Collyhurst Village

Transport Assessment
Supplementary Information v1.1
ISSUE

Far East Consortium Limited

This Transport Assessment Supplementary Information note has been produced to respond to the comments received from Manchester City Council highway officers on 6 April 2021 relating to the planning application for 100 houses and 76 apartments in Collyhurst Village, north east of Manchester city centre (planning application reference 129393/VO/2021).

Figure 1 Route Plan

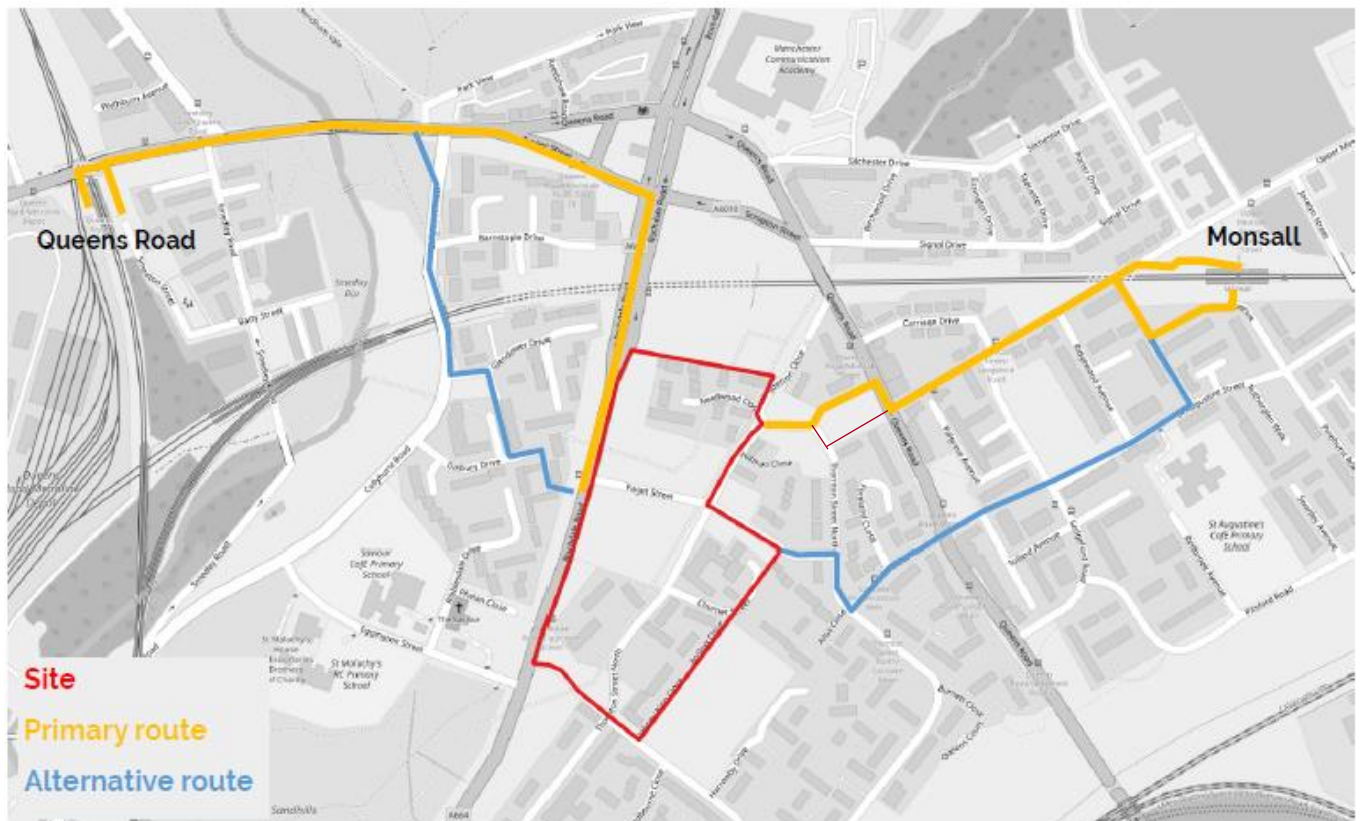
The routes assessed are shown in Figure 1.

Distribution Diagrams

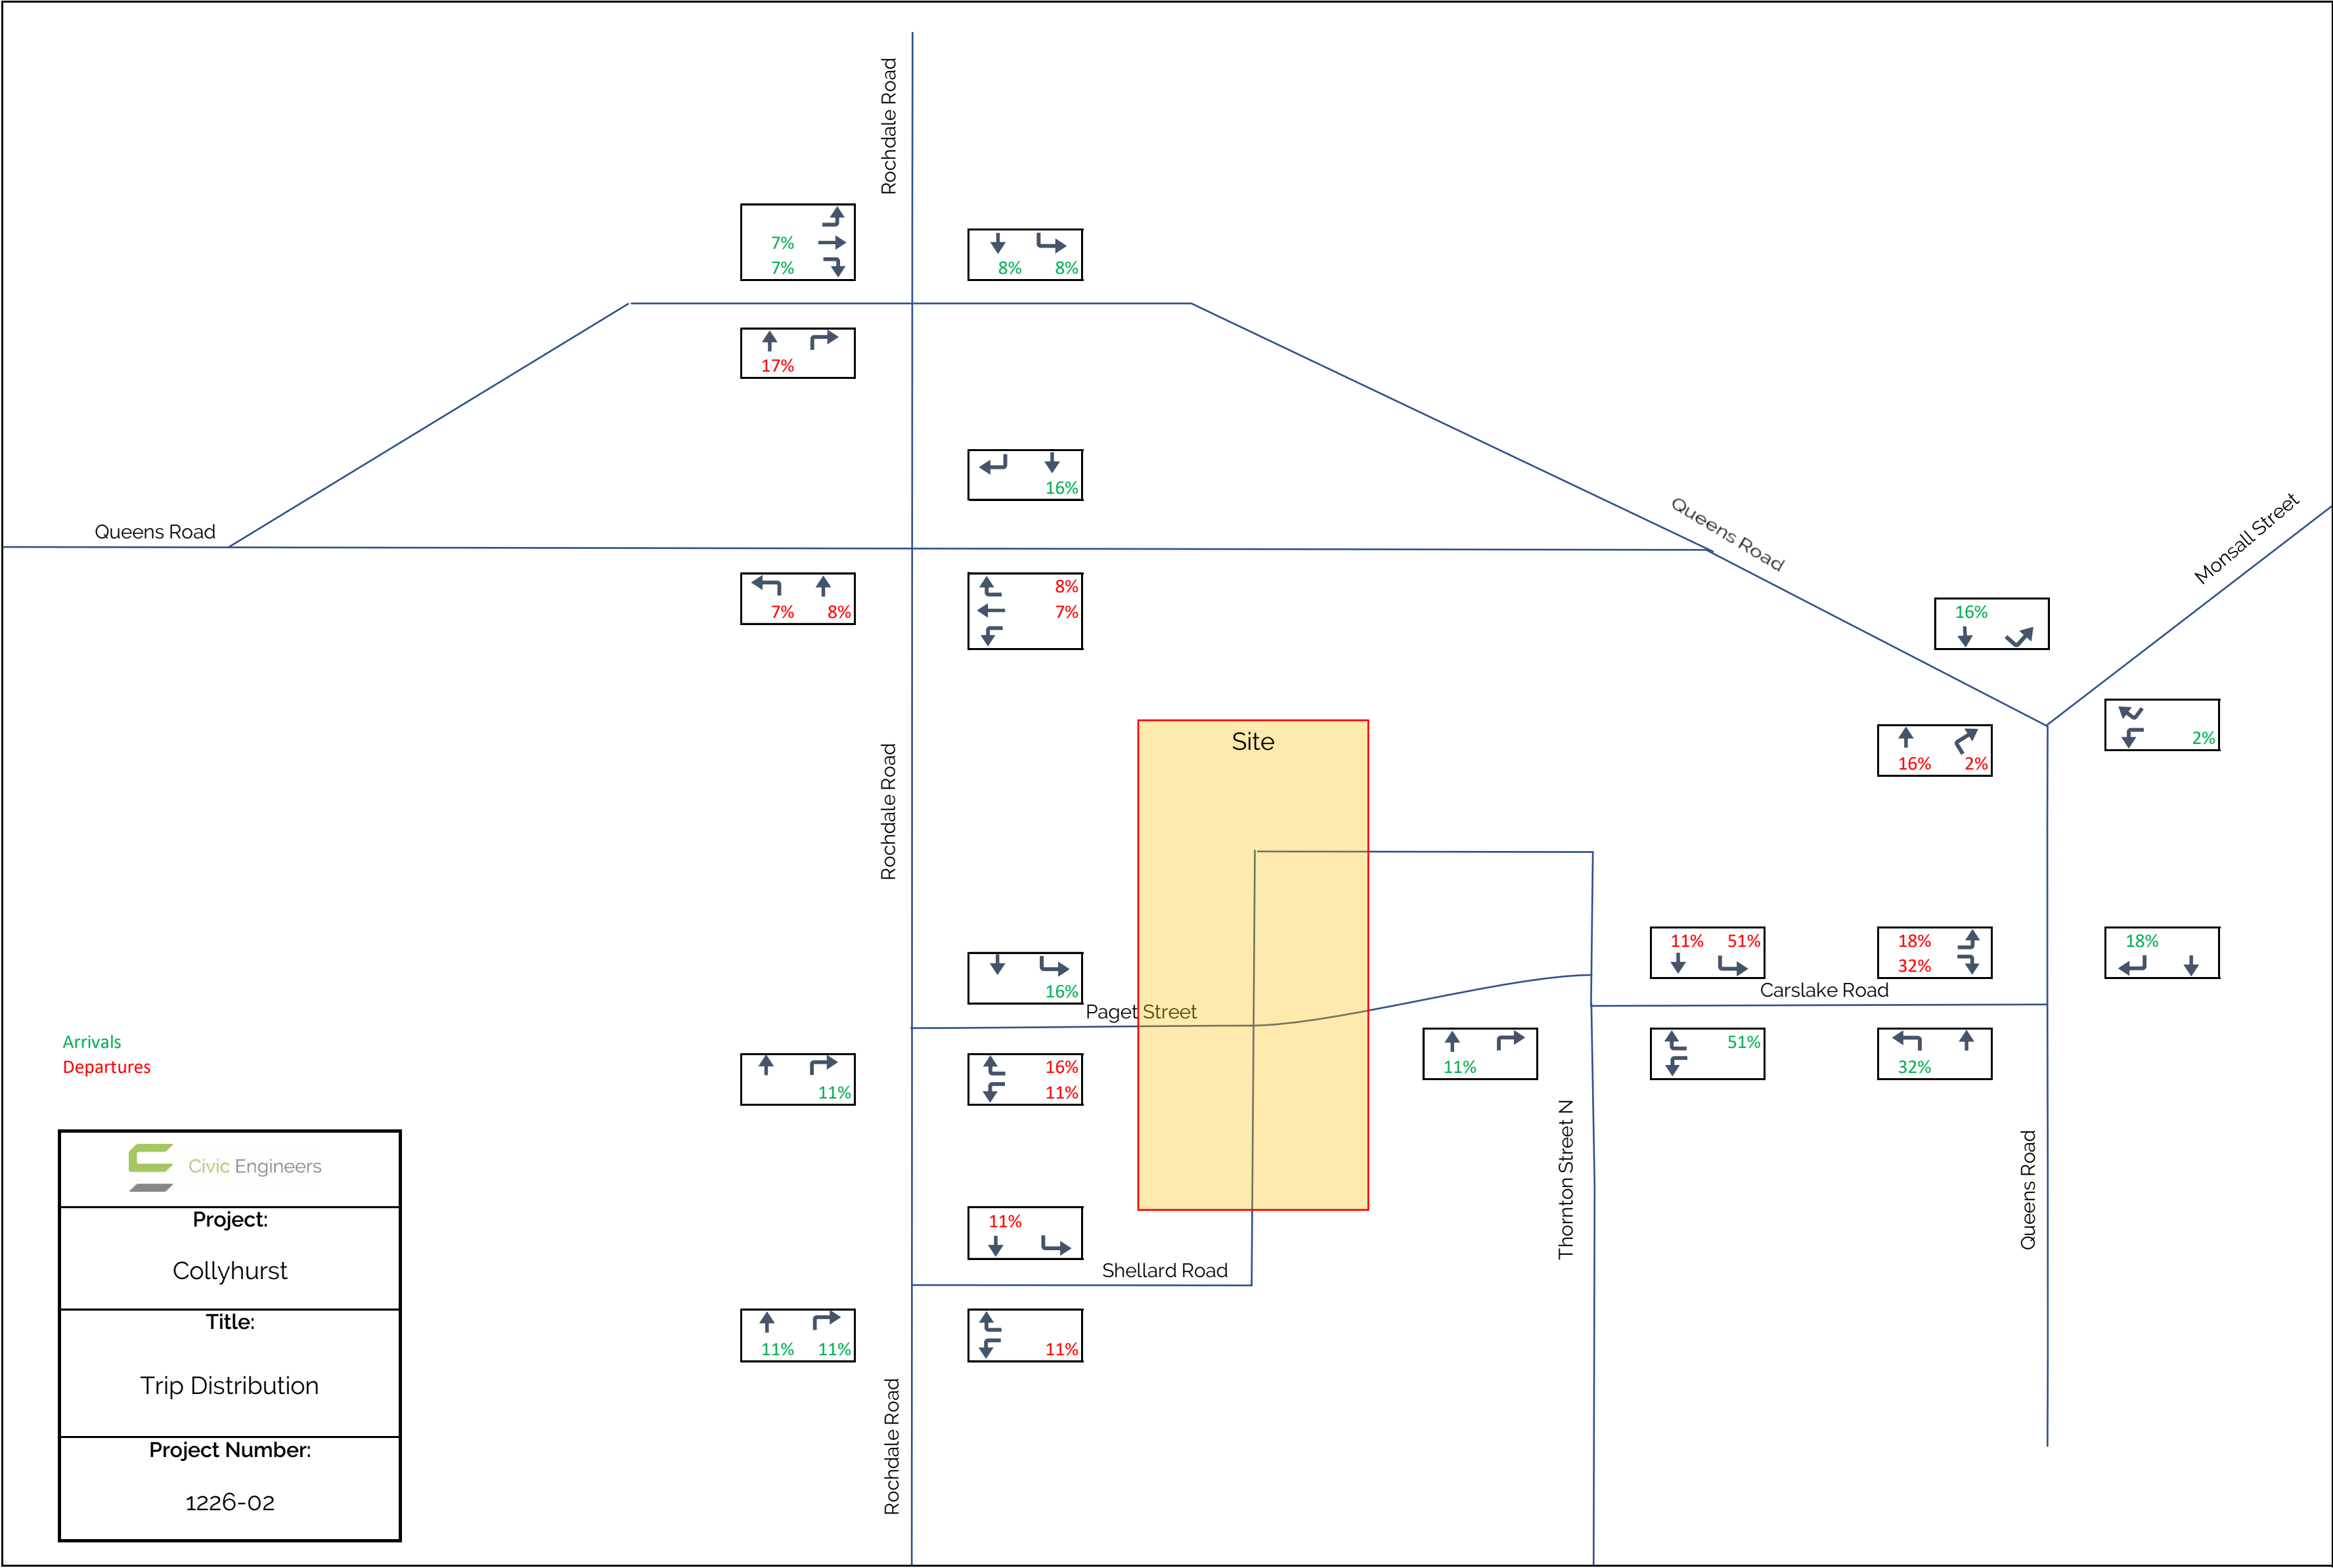
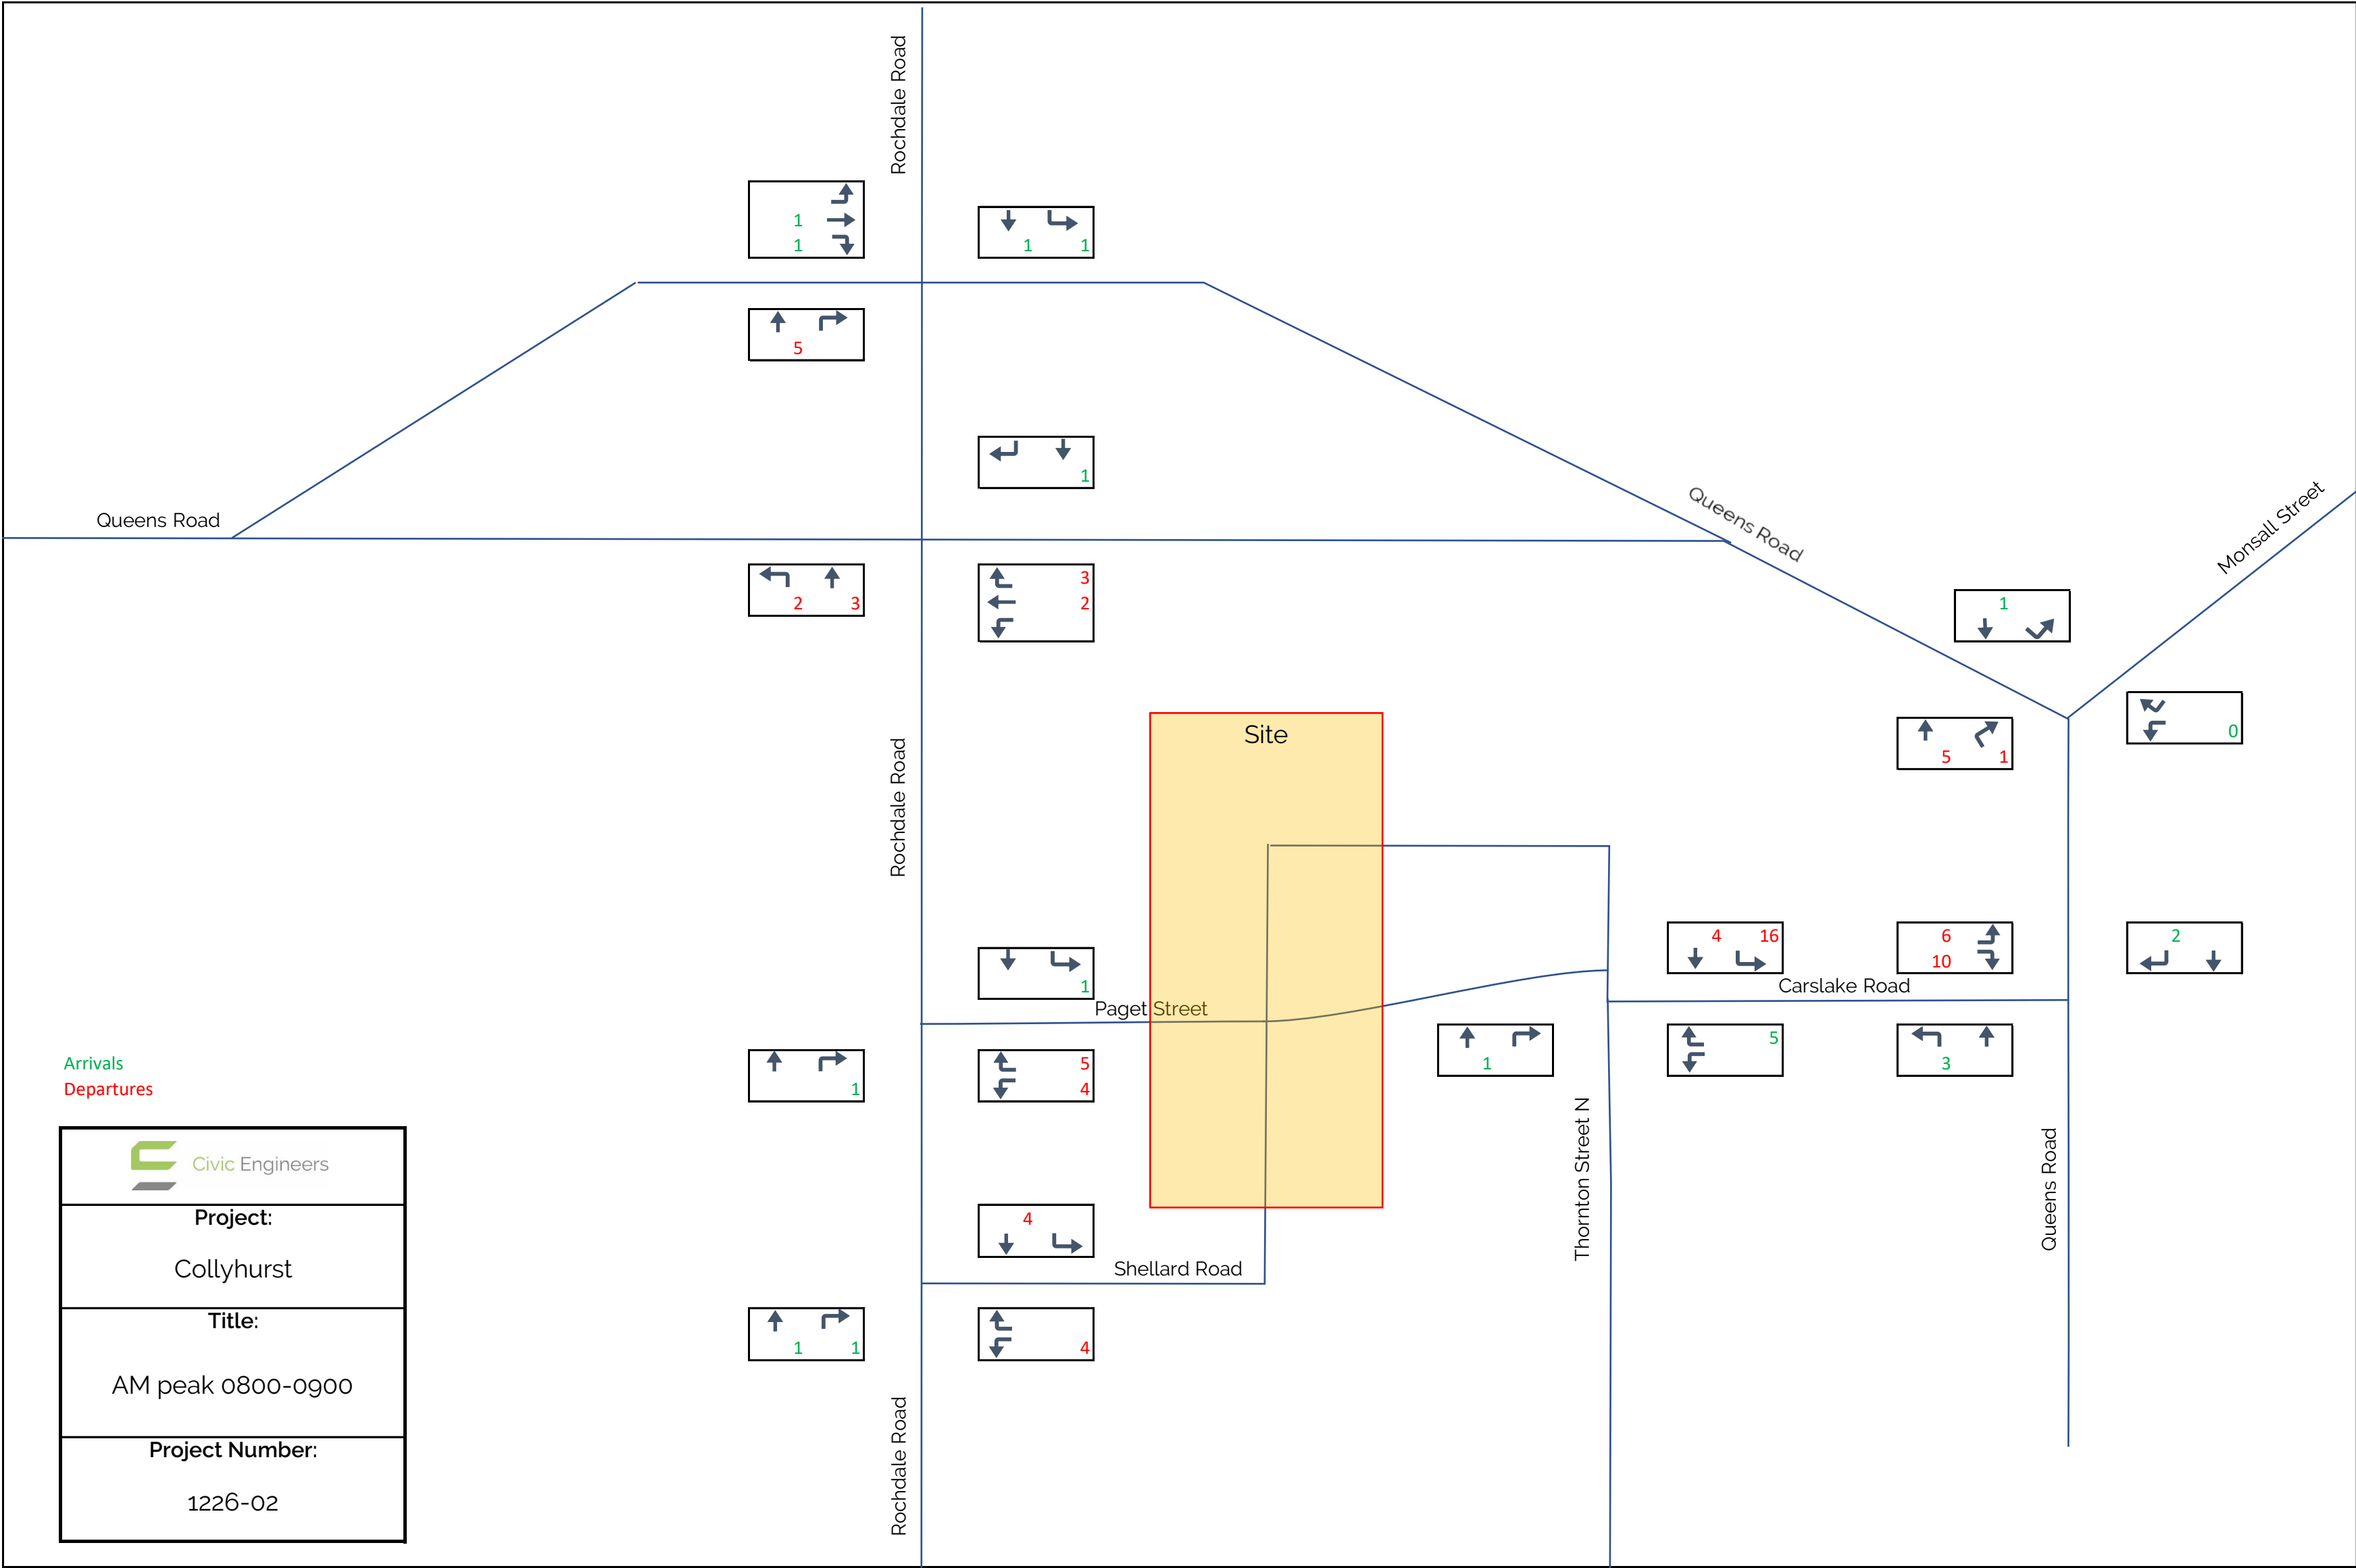
The distribution of vehicle trips is set out in Table 1 and shown on the plan at Appendix B. Some of the distribution destinations, such as Rochdale Road north, had more than one way of arriving there, e.g. via the Rochdale Road/Paget Street junction, or via the Thornton Street North/Churnet Street access. Trips were split equally between two route choices.
